ADDENDUM C – PLAN APPROVAL ADDENDUM

Hardaway B Main Floor

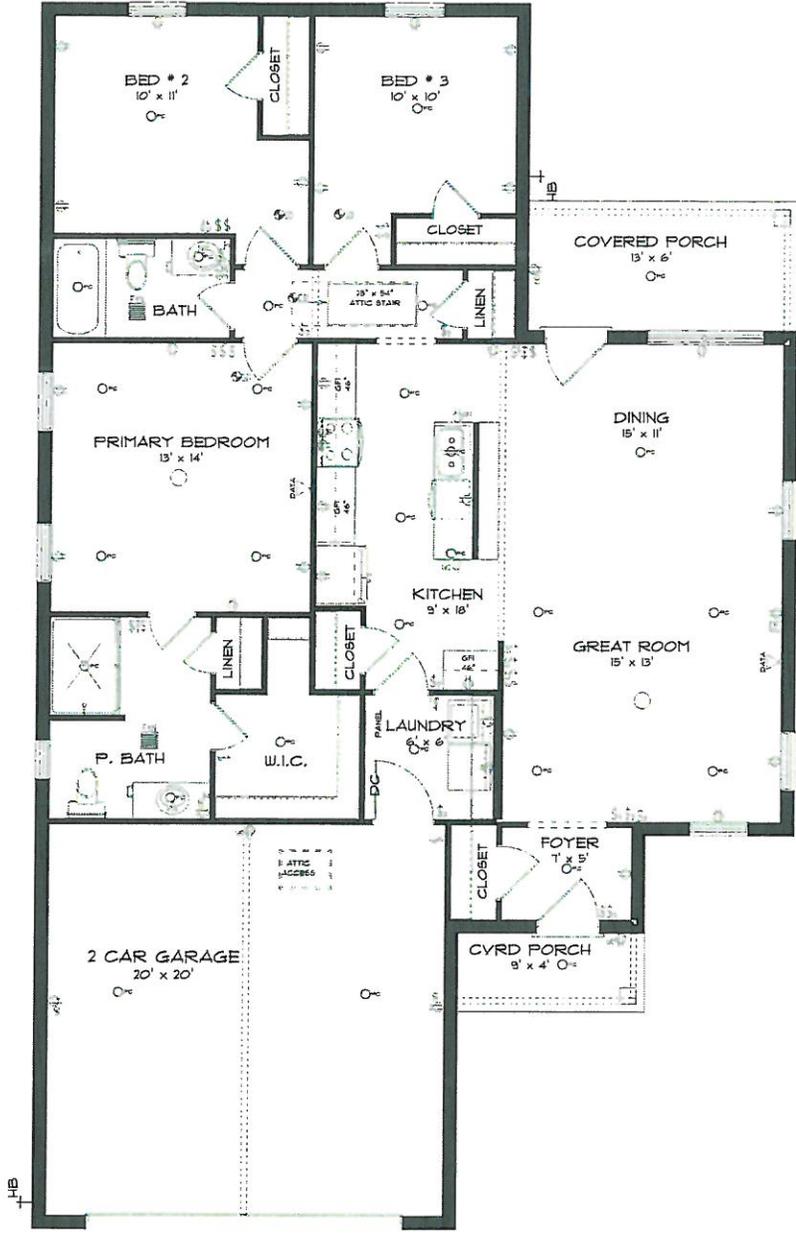
Add
SS French
Door
Refrig

Add
2" faux wood
Blinds
